SERVICE BULLETIN

ENGINE - DIFFUSER AND COMBUSTOR GROUP - PROVIDE NEW DIFFUSER GROUP ADAPTERS AND TUBE ASSEMBLIES - CATEGORY CODE 8 - MOD.ENG-72-0239

V2500-ENG-72-0239

Location of the Tube Assembly and Adapter
Fig.1

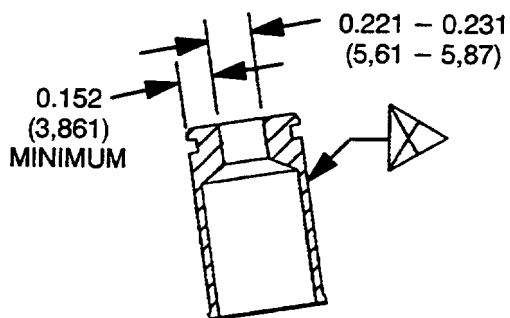
- (1) Install new No. 4 Bearing Outer Tube Assemblies and Tube to Boss Adapters.

- (1) Do a modification of the 2A1031-01 No. 4 Bearing Tube Assembly (3 off). See Reference (3) or (4), 72-42-20 Figure/Item No. 05-020).

Modification of the Tube Assembly, Tube and Adapter
Fig.2

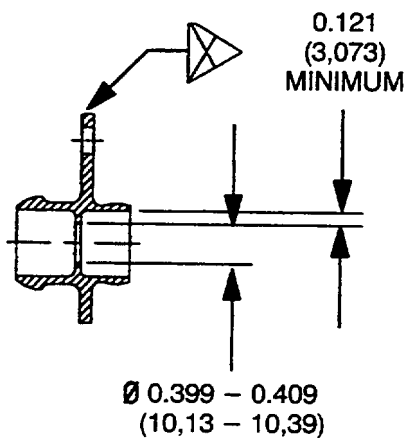
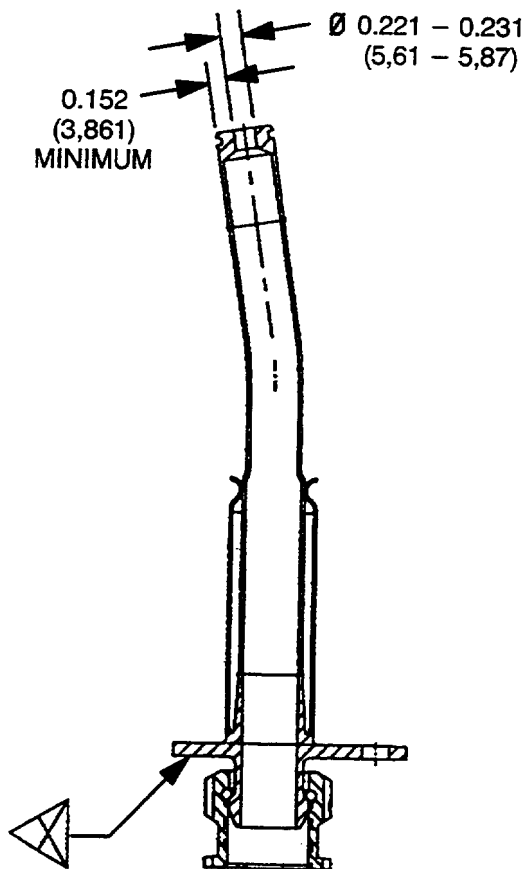
- (a) Set-up and machine to open the 0.204-0.214 in. (5,18 - 5,44 mm) diameter to 0.221 - 0.231 in. (5,61 - 5,87 mm) diameter.

- 1 Break sharp edges 0.003 - 0.005 inch (0,08-0,38 mm).

- (a) Set-up and machine to open the 0.204-0.214 in. (5,18 - 5,44 mm) diameter to 0.221 - 0.231 in. (5,61 - 5,87 mm) diameter.

- 1 Break sharp edges 0.003 - 0.015 inch (0,08-0,38 mm).

- (a) Set-up and machine to open the 0.315-0.325 in. (8,00 - 8,26 mm) diameter to 0.399 - 0.409 in. (10,13 - 10,39 mm) diameter.

- 1 Break sharp edges 0.003 - 0.015 inch (0,08-0,38 mm).

Family Tree - No. 4 Bearing Outer Tube Assembly Ref. Catalog Sequence No 72-42-20.
Fig. 05 Item 020
Fig.3

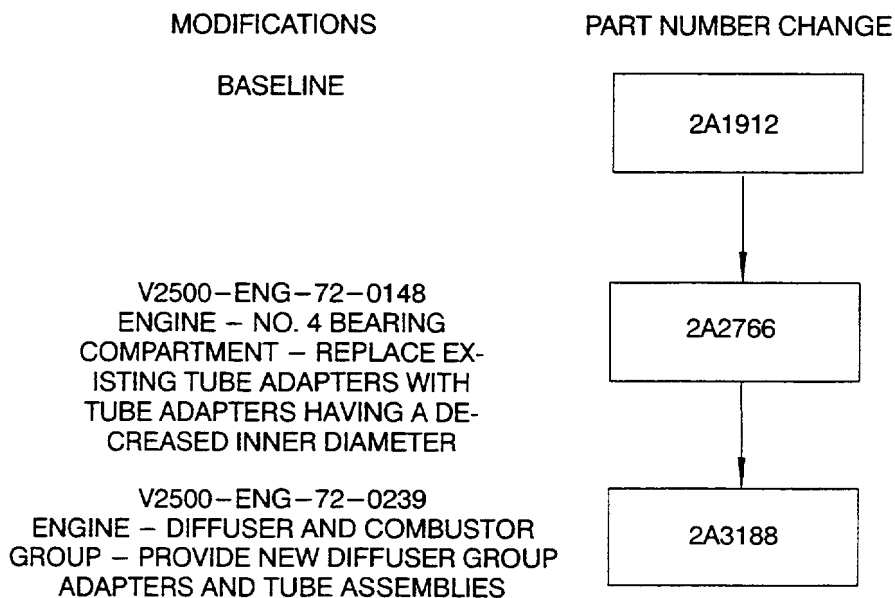
Existing	New Part Number
2A1031-01	2A3187-01
